DELEGATED APPLICATION REPORT

Address: Land between Weldale Street and Chatham Street, Reading

Application No: 221160/NMA

Proposal: Non-material amendments to planning permission 170326, as granted 15/03/2018, to amend the description of development and, by consequence, alter the wording of conditions 2 (approved plans), 38 (energy measures) and 49 (unit mix) (as added by 191974) to incorporate a reduction from 427 to 418 residential units (reduction to 422 already agreed through 191974) to provide an internal amenity space (Class C3) for Block B residents, various external alterations to Block B windows, doors and entrances, introduction of roof-level solar PV panels and blue/green roof, hot water air source heat pumps in place of CHP plant, provision of attenuation tank, sprinkler tank, pump room and additional electric vehicle charging points at lower ground floor level and associated works.

Extract of originally approved and now proposed ground floor plan

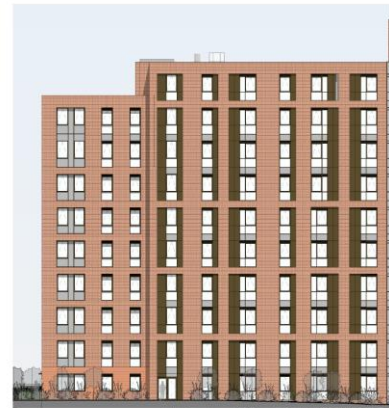
At ground floor level on the southern side of the Block B development it is proposed to remove 3 approved residential units and instead provide amenity space for future occupiers, in the form of an ancillary lounge/screen/dinner room at ground floor level. Such changes would improve the quality of accommodation for future occupiers of Block B and are considered a non-material change in the context of the scheme as a whole. Separate assessment of the resultant reduction in residential units is provided in the 'reduction from 427 to 418 residential units' section above. It is also relevant to note that a similar change was incorporated within Block A as part of separate NMA 191974.

Extract of west elevation of Block B2

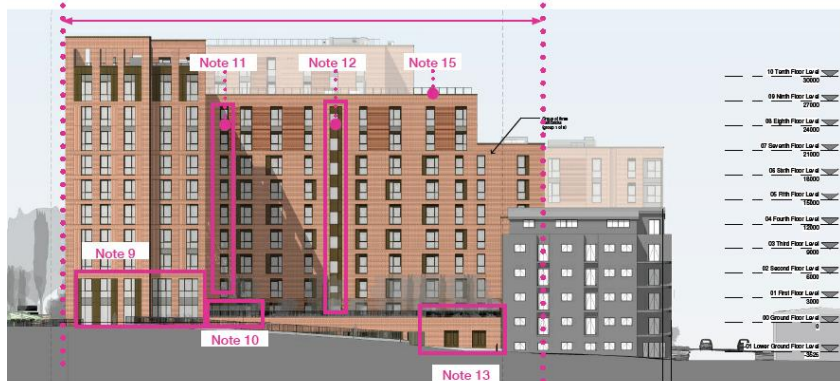
To facilitate a number of the internal changes some associated external works are proposed, as shown in the comparative visuals below. It is evident that the nature and extent of the changes are minimal and linked to the works, rather than a re-design of the scheme. The changes follow the design idiom of the original scheme and are considered to constitute non-material changes to the scheme.

Proposed Site Elevation - East, 1:500 (Drawing 3622-SC-0303F)

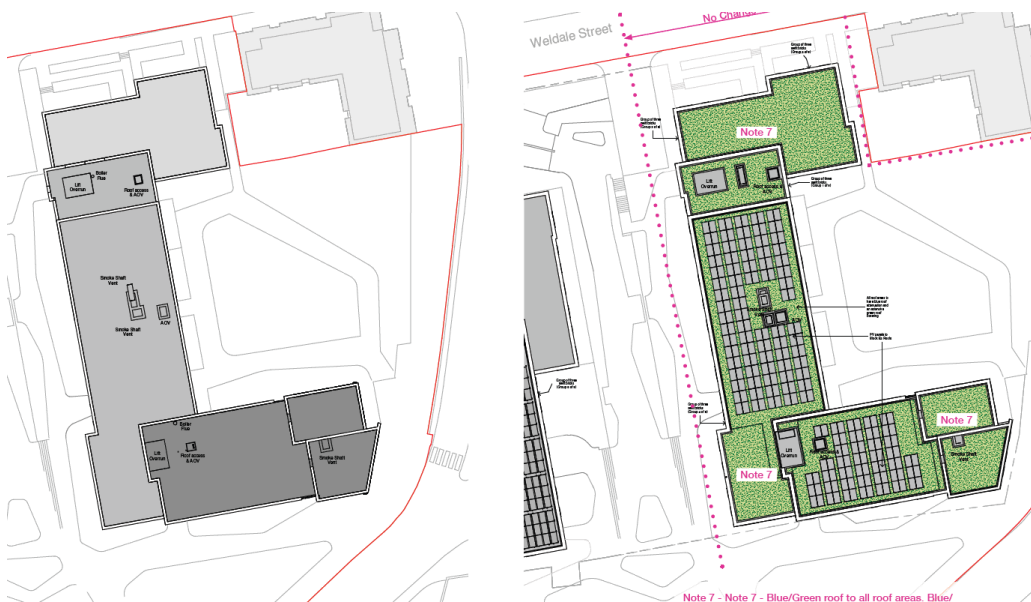
Summary of changes:

Note 9 - Fenestration updated to suit updated levels and new amenity areas

Note 13- Substation doors updated In line with UKPS requirements

Note 15- PVs + Edge Protection to roof areas
